ERRATA LIST

Artasie AMX8X5 RTC ER0007

Real-Time Clock devices with certain date codes

A-RTCA85-ELGA02EN v2.0

Figure 3-2: VCC High to nRST High ($t_{VH:NRST}$) Delay Extension

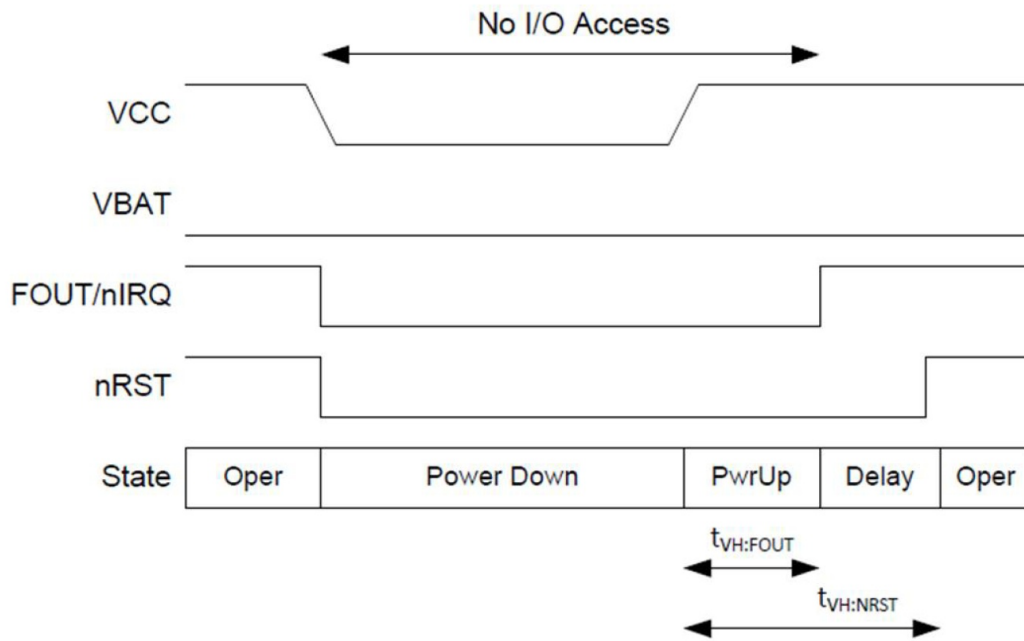
For the affected devices specified by this erratum, the delay to nRST high will be extended over the current datasheet specification due to different nRST delay timing on these devices. This increases the delay for nRST high after power-up reset ($t_{VH:NRST}$) as shown in Figure 3-2 on page 8, and after exit from sleep (t_{RSTIM}) as shown in Figure 3-3 on page 8, by an additional 100 – 300 ms.
